FINAL DRAINAGE REPORT
FOR
SADDLEHORN RANCH – FILING 3

February 4, 2022
Project No. 25142.05

El Paso County PCD File No.:
SF234

MS4 PERMIT EXCLUSION AREAS
SADDLEHORN RANCH FILING 3
JOB NO. 25142.05
1/7/22
SHEET 1 OF 1

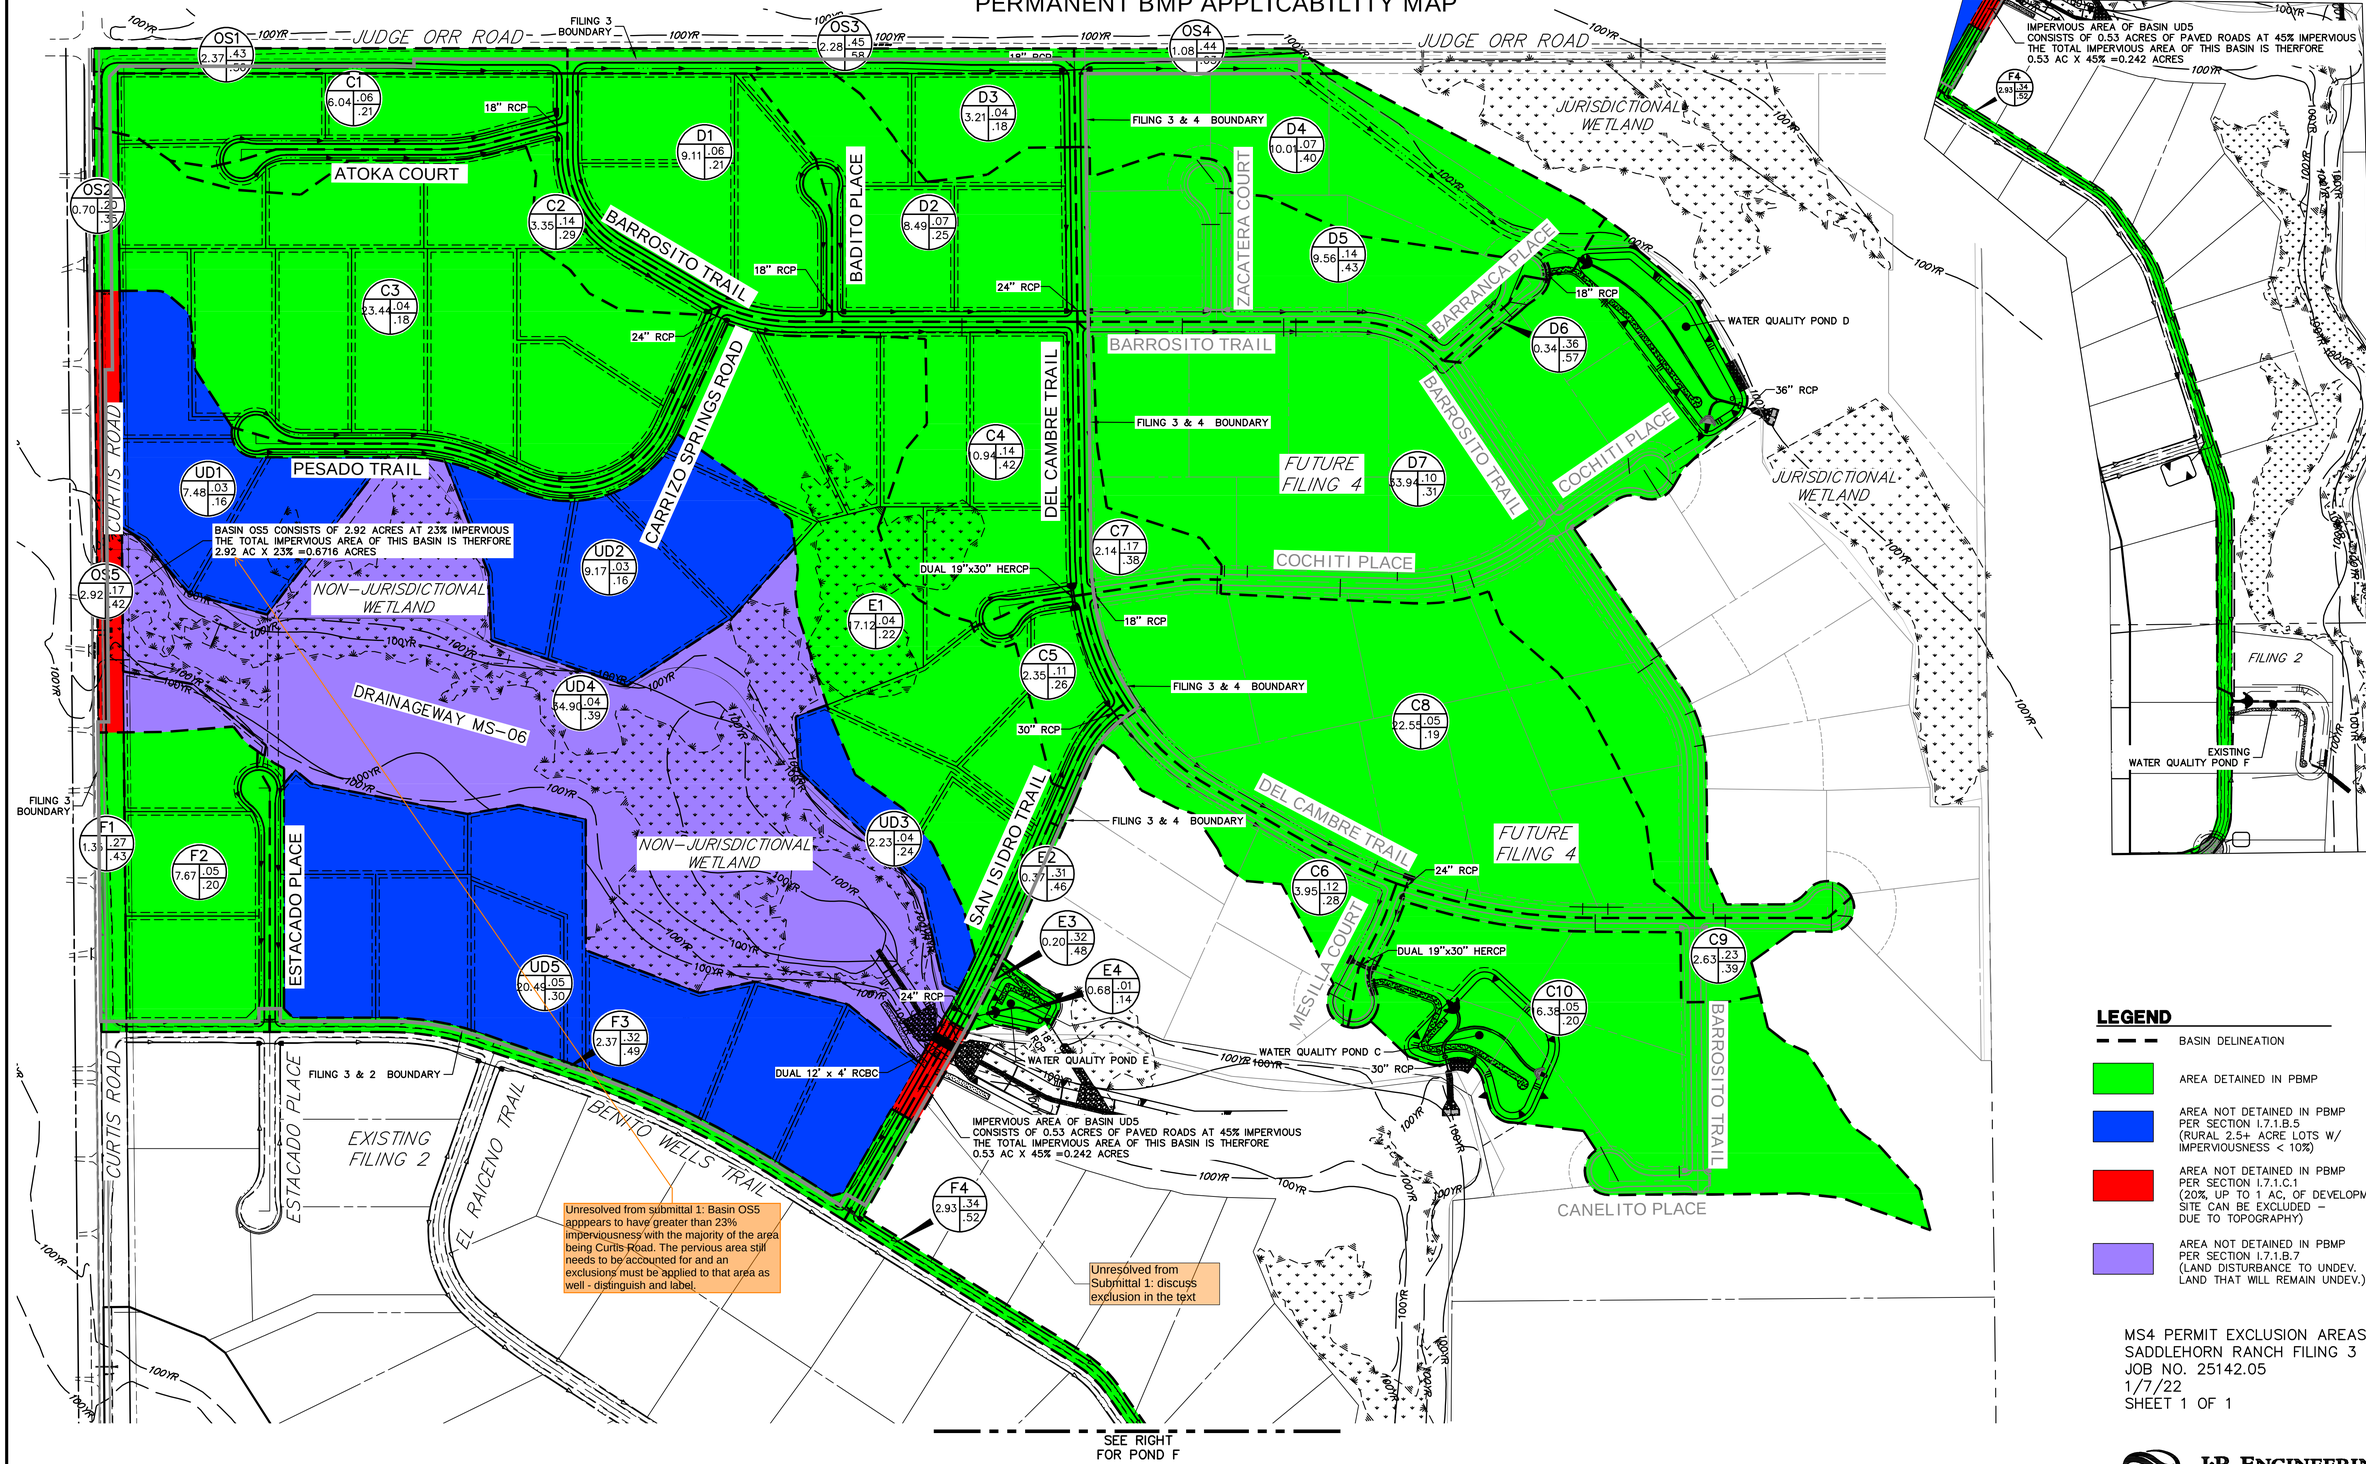
Unresolved from submittal 1: Basin OS5 apppears to have greater than 23% imperviousness with the majority of the area being Curtis Road. The pervious area still needs to be accounted for and an exclusions must be applied to that area as well - distinguish and label.
